Town of Hilton Head Island Regular Design Review Board Meeting

AGENDA

PROJECT NAME: Stacks Pancakes – ALTERATION/ADDITION

DRB#: DR 130027

THE PANTRY, INC.
 HILTON HEAD, SOUTH CAROLINA
 KANGAROO EXPRESS STORE #400
 LANDSCAPE PLAN

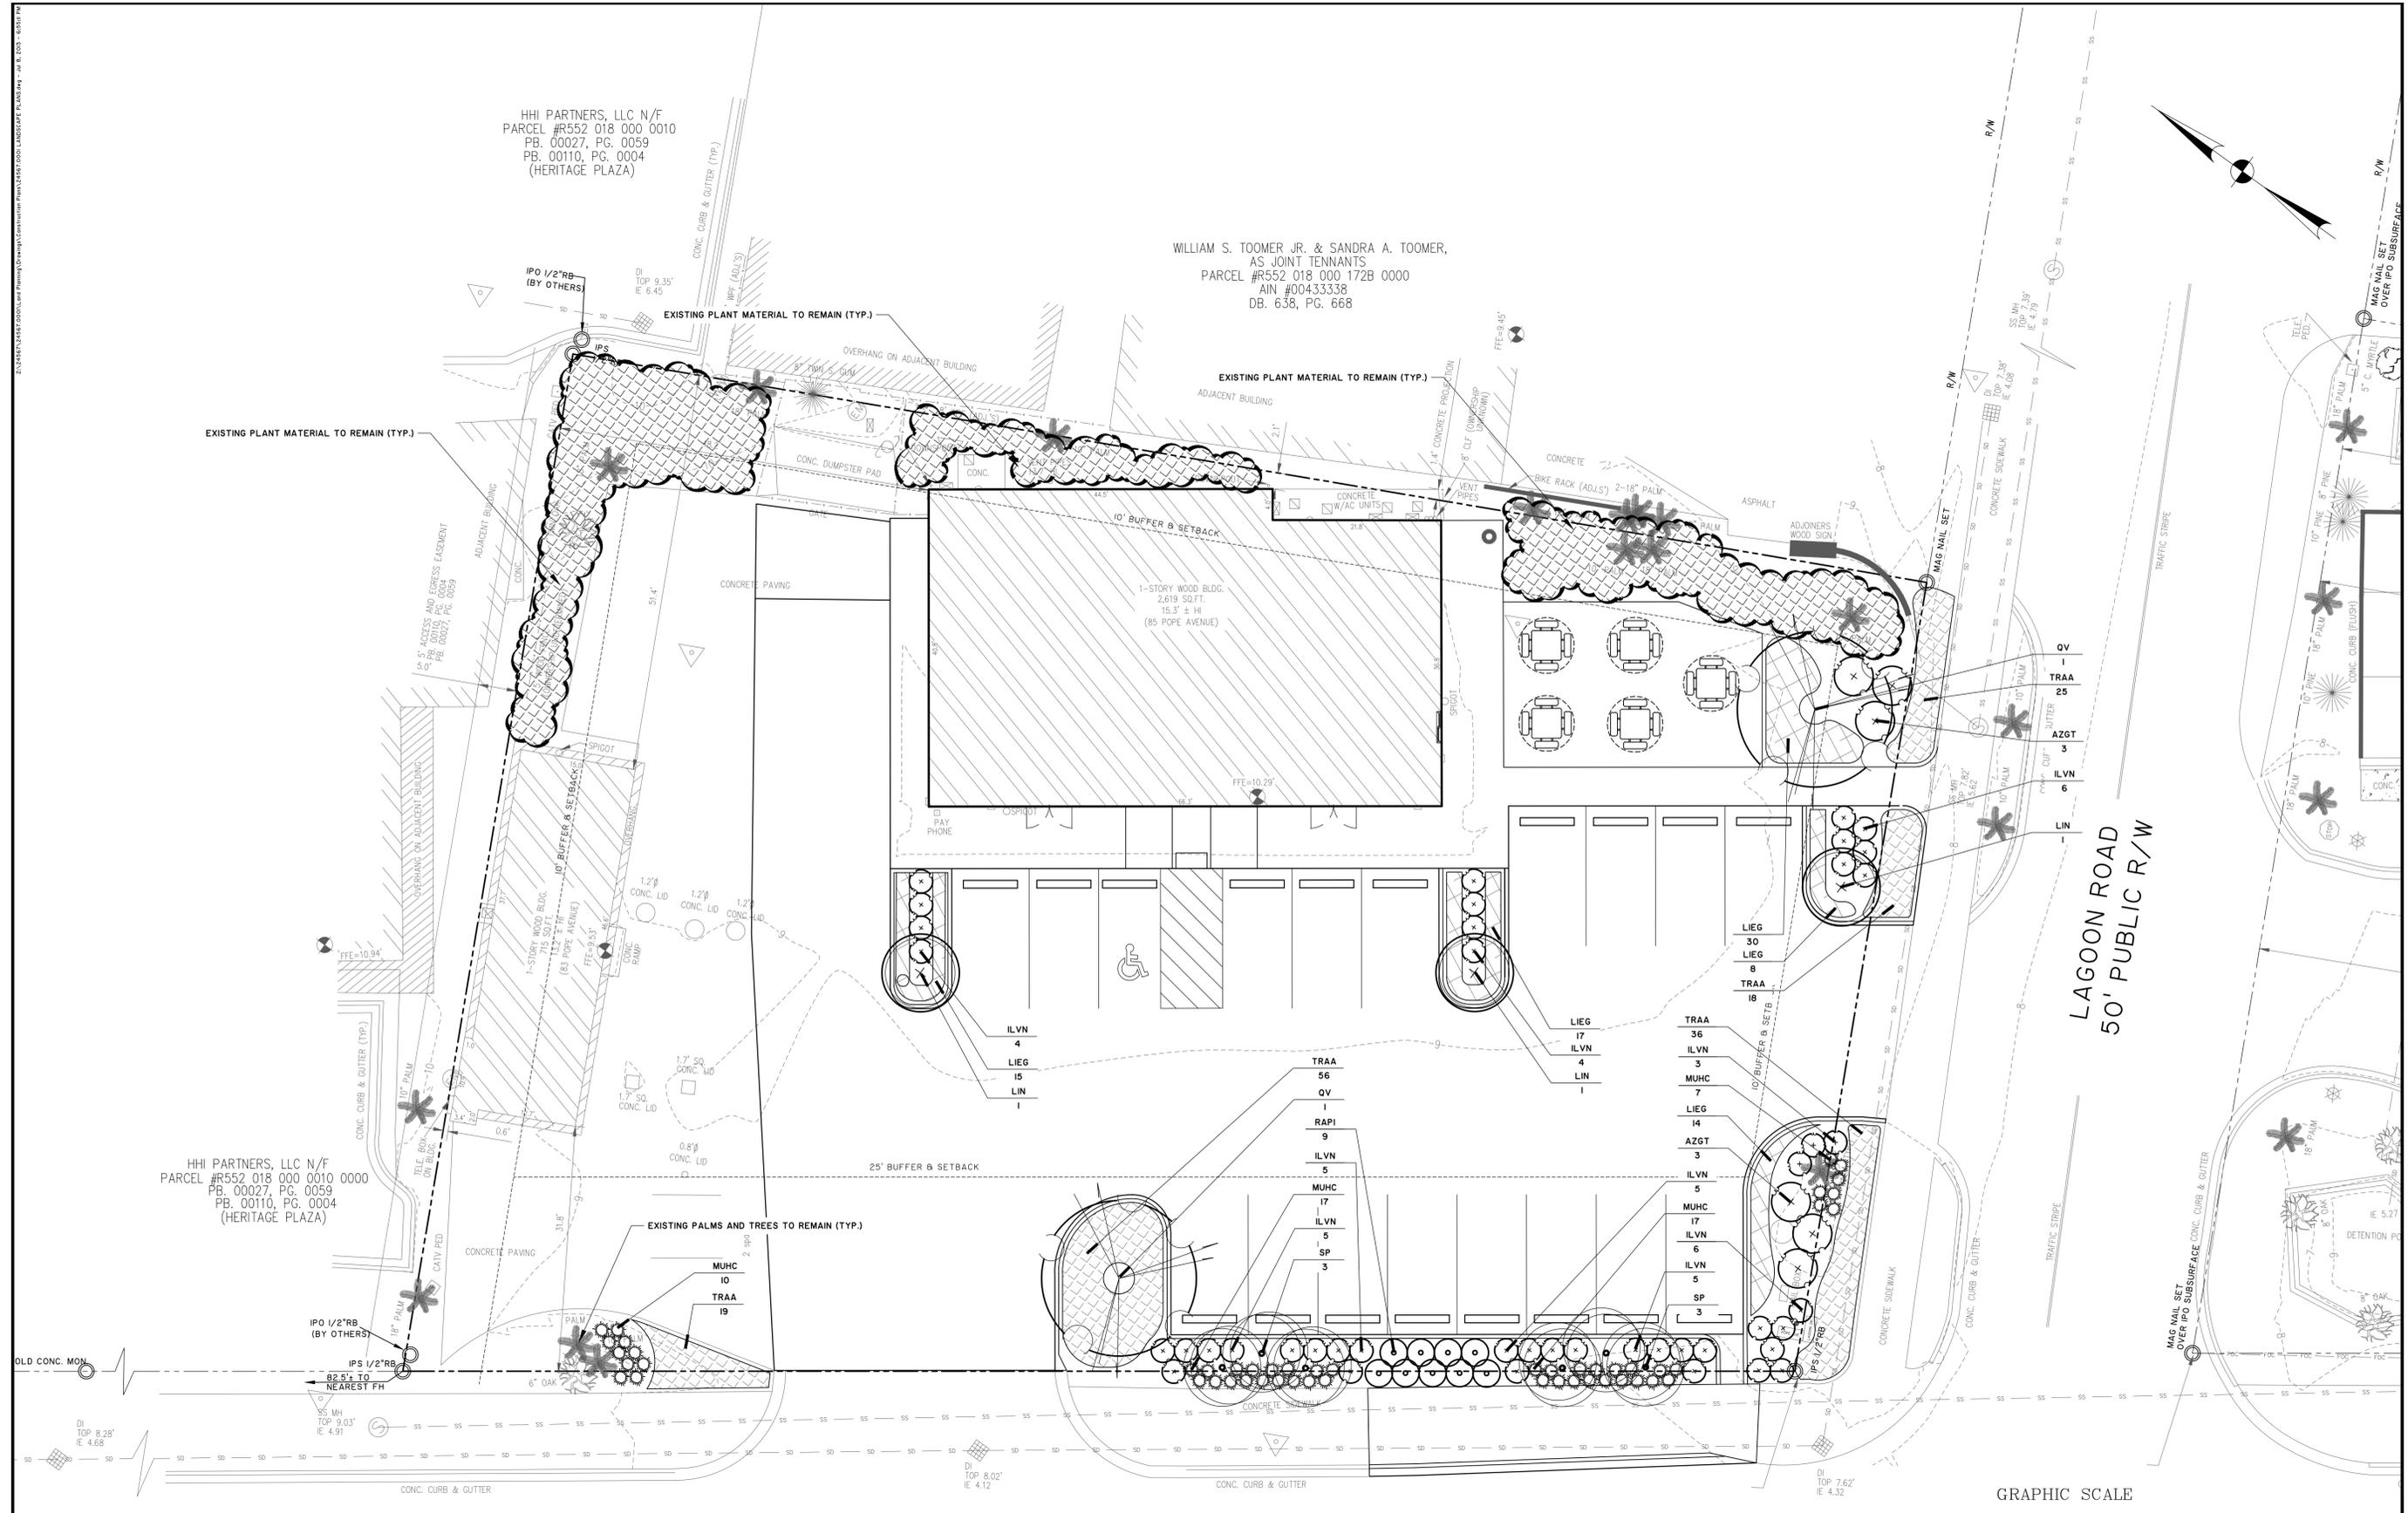
LANDSCAPE DESIGN				
DESIGN GUIDE/LMO CRITERIA	Complies Yes	No	Not Applicable	Comments or Conditions
Treats the Landscape as a major element of the project	<input checked="" type="checkbox"/>	<input type="checkbox"/>	<input type="checkbox"/>	Existing site contains little-to-no landscaping. Amount and type of proposed landscaping on redevelopment plan is an improvement.
Provides Landscaping of a scope and size that is in proportion to the scale of the development	<input checked="" type="checkbox"/>	<input type="checkbox"/>	<input type="checkbox"/>	Parking lot islands have been added and are all landscaped as well as adding landscape buffer between parking lot and sidewalk at Pope Avenue.
Landscape is designed so that it may be maintained in its natural shape and size	<input checked="" type="checkbox"/>	<input type="checkbox"/>	<input type="checkbox"/>	
Preserves a variety of existing native trees and shrubs	<input checked="" type="checkbox"/>	<input type="checkbox"/>	<input type="checkbox"/>	Limited number of existing trees; all are to remain.

Shrubs are selected to complement the natural setting, provide visual interest and screen less desirable elements of the project	<input checked="" type="checkbox"/>	<input type="checkbox"/>	<input type="checkbox"/>	
A variety of species is selected for texture and color	<input checked="" type="checkbox"/>	<input type="checkbox"/>	<input type="checkbox"/>	Includes variety of grasses, evergreen shrubs, flowering shrubs, and ground covers.
Provides overall order and continuity of the Landscape plan	<input checked="" type="checkbox"/>	<input type="checkbox"/>	<input type="checkbox"/>	
Native plants or plants that have historically been prevalent on the Island are utilized	<input checked="" type="checkbox"/>	<input type="checkbox"/>	<input type="checkbox"/>	Plant palette includes crape myrtle, live oak, sabal palmetto, azalea, dwarf yaupon holly, etc.
A variety of sizes is selected to create a "layered" appearance for visual interest and a sense of depth	<input checked="" type="checkbox"/>	<input type="checkbox"/>	<input type="checkbox"/>

The location of existing mature trees is taken into account in placement of shrubs so as not to damage tree roots	<input type="checkbox"/>	<input type="checkbox"/>	<input checked="" type="checkbox"/>	
Proper spacing and location for plants to reach their mature size and natural shape while avoiding excessive or unnatural pruning	<input checked="" type="checkbox"/>	<input type="checkbox"/>	<input type="checkbox"/>	
Proposed groundcovers are evergreen species with low maintenance needs	<input checked="" type="checkbox"/>	<input type="checkbox"/>	<input type="checkbox"/>	Proposed groundcovers include 'Evergreen giant' liriope and Asiatic jasmine.
Large grassed lawn areas encompassing a major portion of the site are avoided	<input type="checkbox"/>	<input type="checkbox"/>	<input checked="" type="checkbox"/>	Grassed lawn areas are not included.
The adjacent development is taken into account in determining the most appropriate buffer so as not to depart too dramatically from the neighborhood	<input checked="" type="checkbox"/>	<input type="checkbox"/>	<input type="checkbox"/>	Existing buffer to rear and side to remain. Consider additional or alternate buffer materials adjacent to proposed outdoor seating.

PROPOSED RIGHT ELEVATION

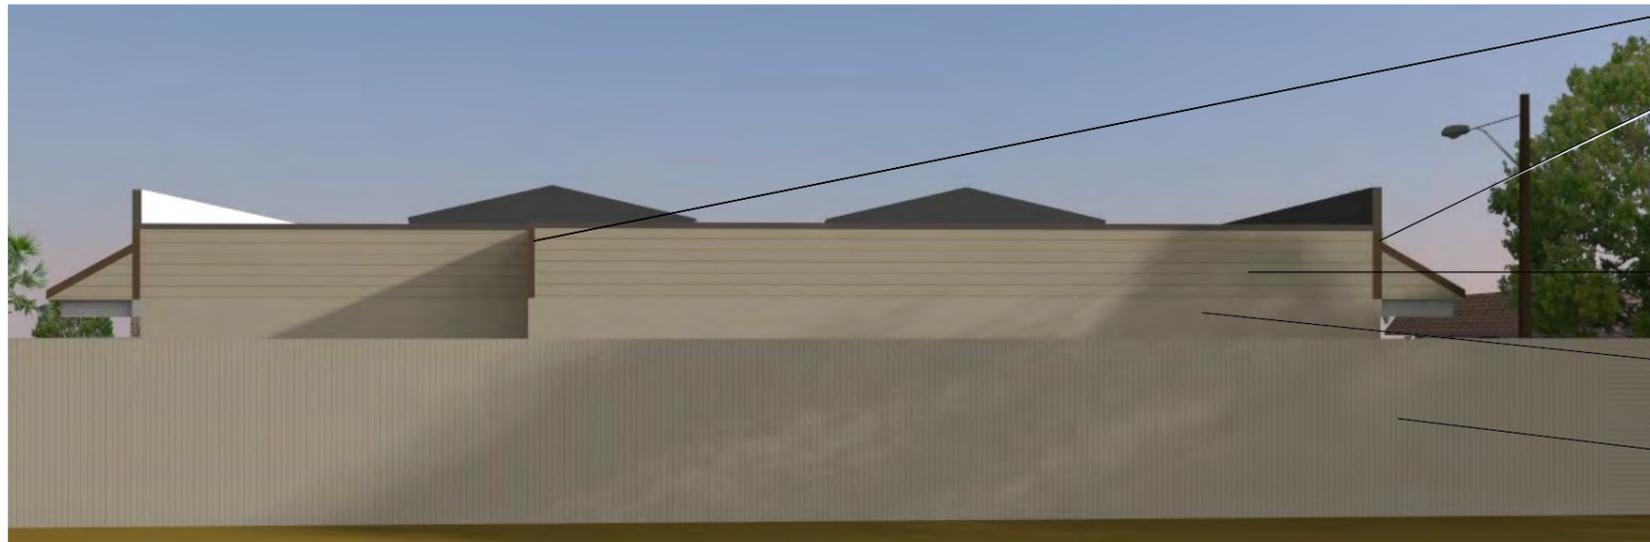
All facades are have equal design characteristics	<input checked="" type="checkbox"/>	<input type="checkbox"/>	<input type="checkbox"/>	Except rear which is completely hidden from view
Avoids monotonous planes or unrelieved repetition	<input checked="" type="checkbox"/>	<input type="checkbox"/>	<input type="checkbox"/>	
Has a strong roof form with enough variety to provide visual interest	<input checked="" type="checkbox"/>	<input type="checkbox"/>	<input type="checkbox"/>	
Minimum roof pitch of 6/12	<input type="checkbox"/>	<input type="checkbox"/>	<input type="checkbox"/>	Roof pitch at entrance unknown. Flat roof on sides with sloped awning.
Overhangs are sufficient for the façade height.	<input checked="" type="checkbox"/>	<input type="checkbox"/>	<input type="checkbox"/>	
Forms and details are sufficient to reduce the mass of the structure	<input checked="" type="checkbox"/>	<input type="checkbox"/>	<input type="checkbox"/>

Decorative lighting is limited and low wattage and adds to the visual character	<input type="checkbox"/>	<input type="checkbox"/>	<input type="checkbox"/>	Gooseneck fixtures are shown on illustrated elevation. Cut sheets were provided (for area light, bollard light, and wall sconce – not gooseneck fixture). Provide lighting plan indicating location of proposed fixtures. Recommend bronze traditional style fixtures versus white fixtures.
Accessory elements are design to coordinate with the primary structure	<input type="checkbox"/>	<input type="checkbox"/>	<input type="checkbox"/>	No information is included regarding accessory structures (rear enclosure and dumpster enclosure) except color. Existing enclosure is chain link fence with slats; recommend new board-on-board wood fence enclosure.
